To: T10 Technical Committee
From: Rob Elliott, HP (elliott@hp.com)
Date: 8 April 2004
Subject: 03-240r1 SAS-1.1 Internal wide connector and cable

Figure 1 — 4-wide connector picture (from Amphenol)

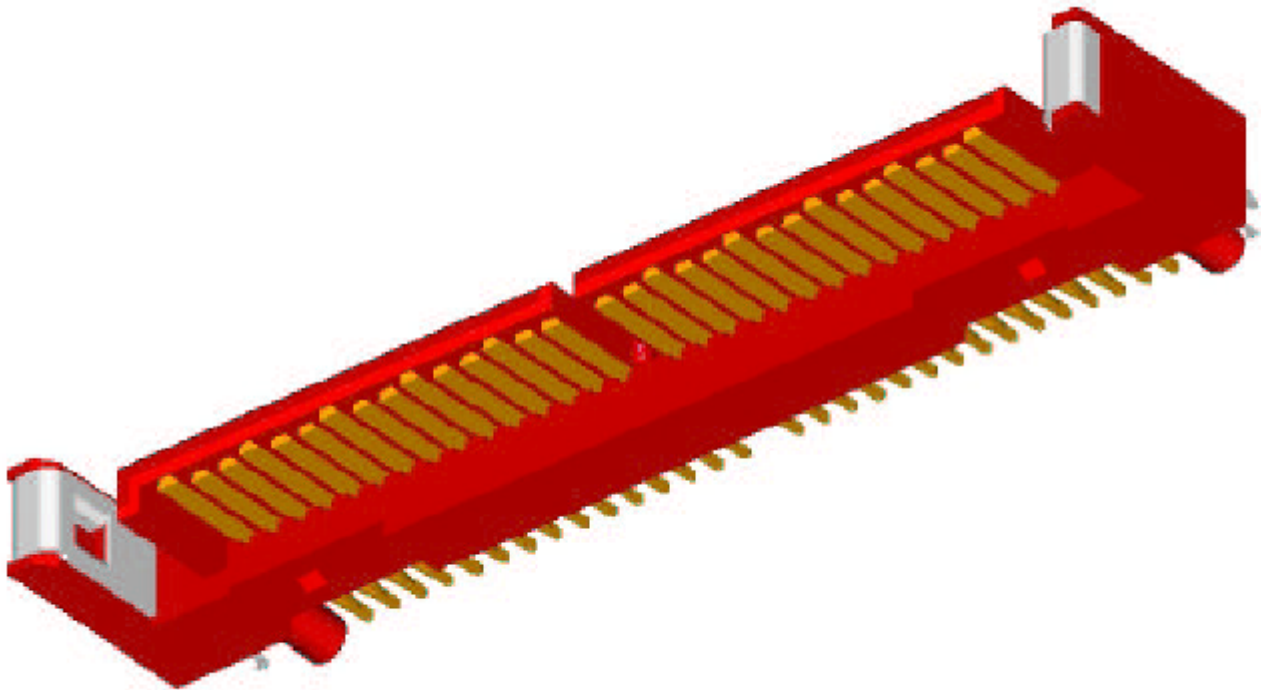
Editor's Note 1: Need an updated figure showing 6 sidebands. Better yet, want two 3D line drawing figures for inclusion in the plug and receptacle sections of the standard itself.

The connector includes 4 high-speed serial channels and 6 sideband signals (in the middle). It is split into two tongues for stability.

Figure 2 — [SAS cables and connectors - internal wide cabled environment](#)

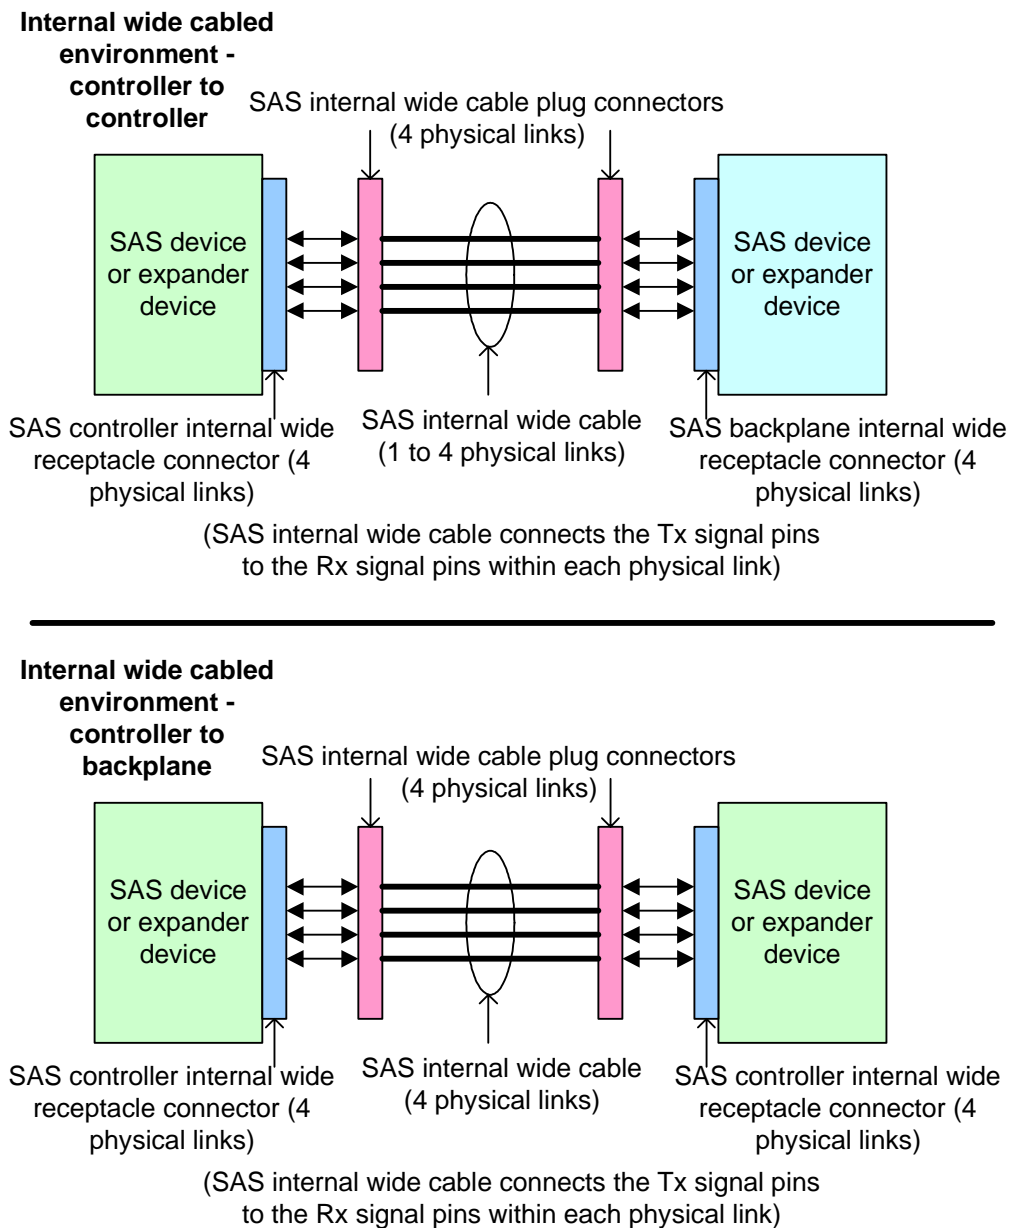
[Figure 2 shows a schematic representation of the cables and connectors defined in this standard for the internal wide environment.](#)

[The internal wide connectors have different pinouts for the controller side and the backplane side so one side's Tx signals are attached to the other side's Rx signals. Two controllers may also be attached together, provided all four physical links are used, since one side's physical link 0 is attached to the other side's physical link 3.](#)

[The internal wide connector contains 6 sideband signals which are crossed when attaching a controller to a backplane but are not crossed when attaching a controller to a controller.](#)

Figure 3 — SAS internal wide cable attaching controller to controller

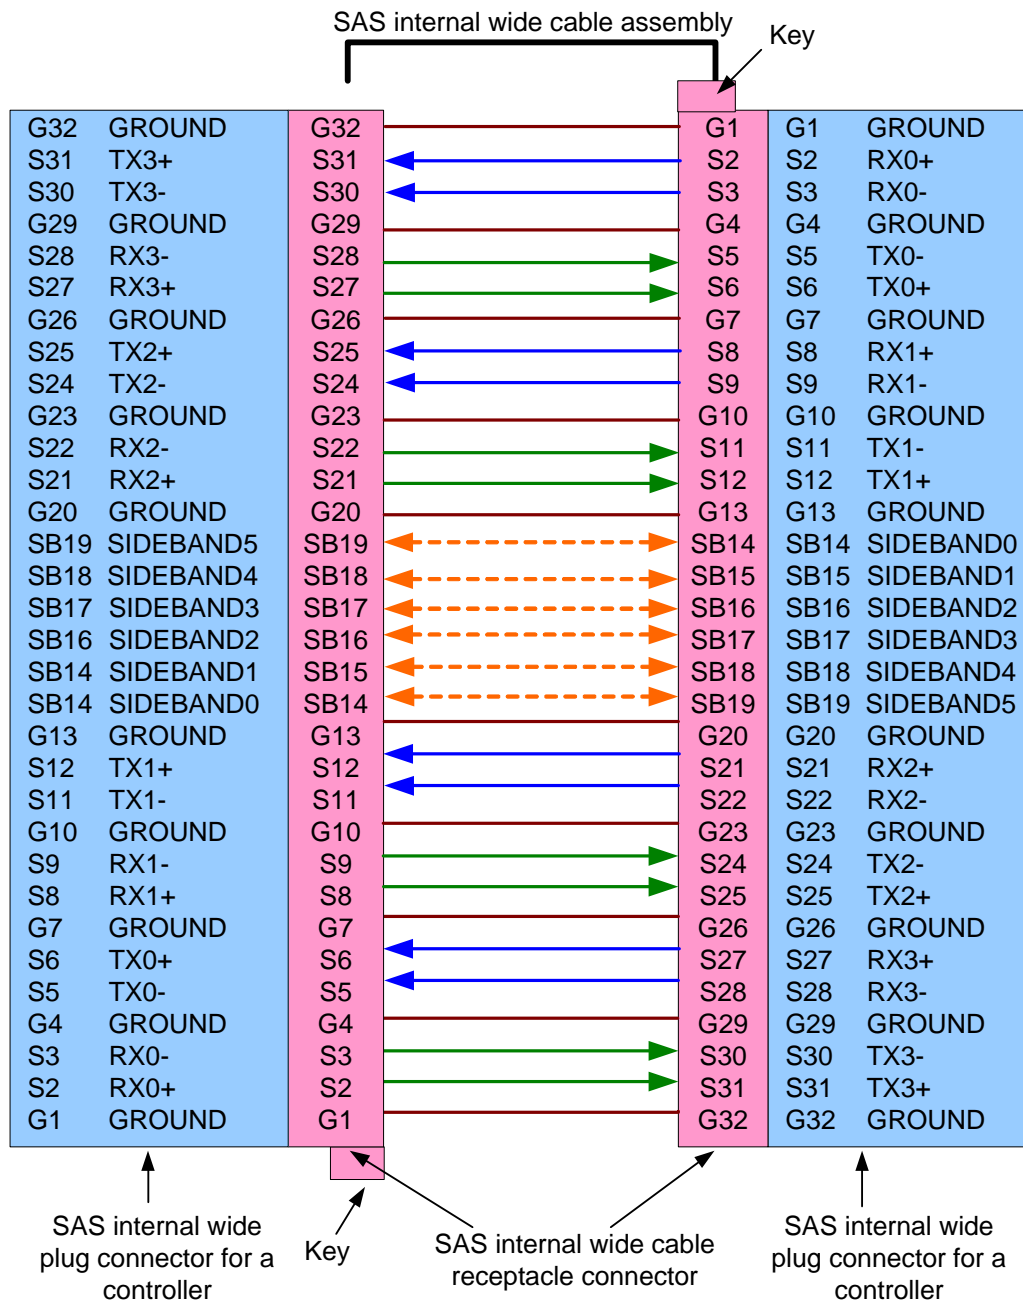
Figure 3 shows the SAS internal wide cable attaching two controllers.

NOTE 2 - For controller to controller applications, all four physical links should be used, because one side's physical link 0 is the other side's physical link 3. If both sides just used physical link 0, they would not communicate. The sideband signals are also crossed.

Figure 4 — SAS internal wide cable attaching controller to backplane

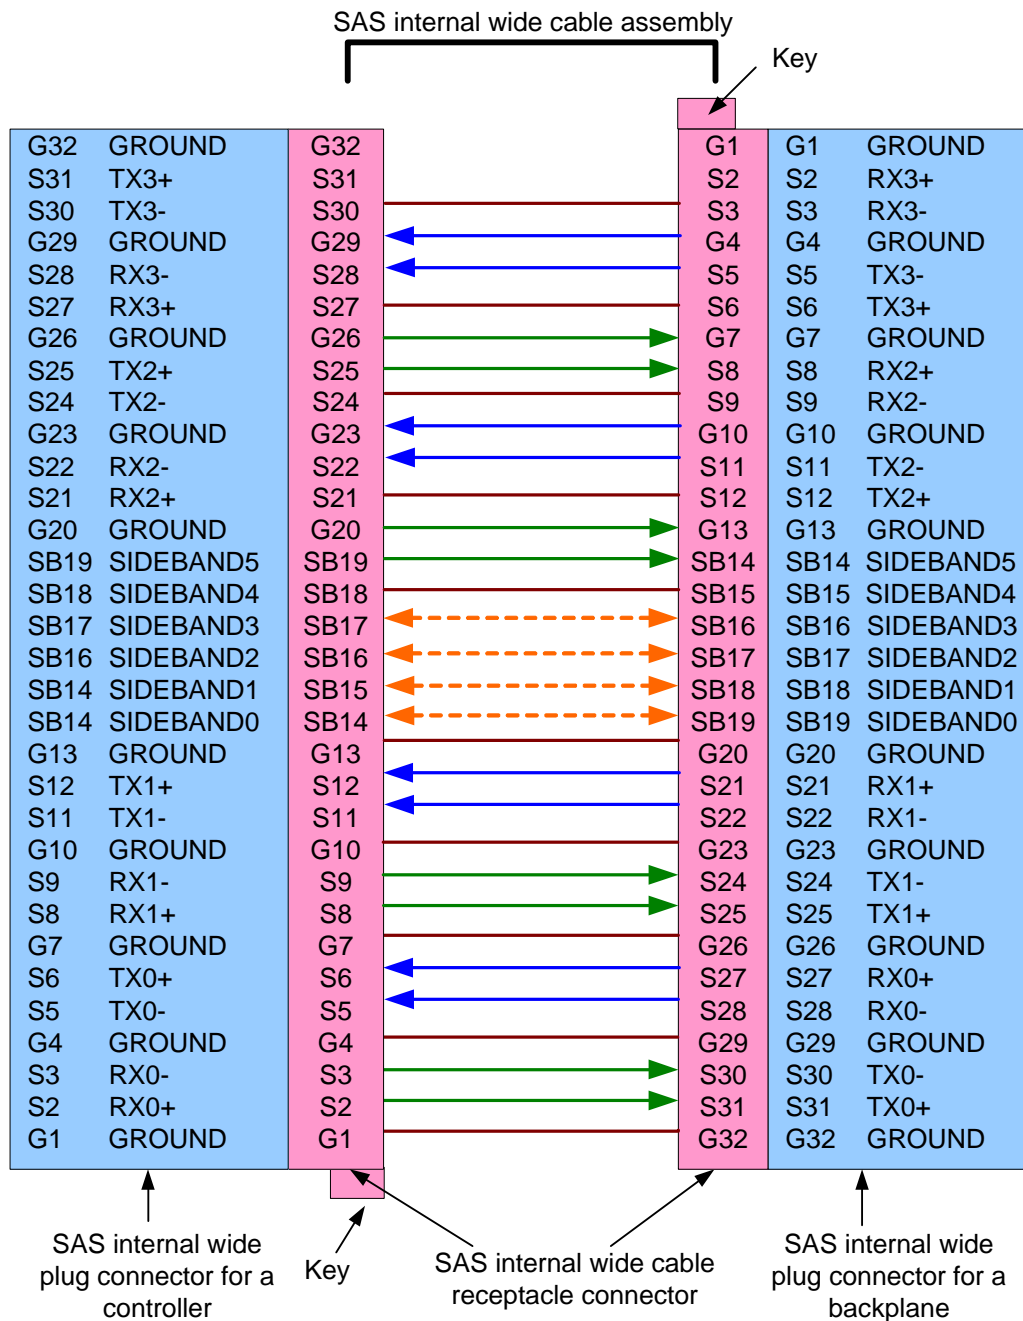
Figure 4 shows the SAS internal wide cable being used to attach a controller to a backplane.

NOTE 3 - For controller to backplane applications, up to four physical links may be used. The sideband signals are not crossed.
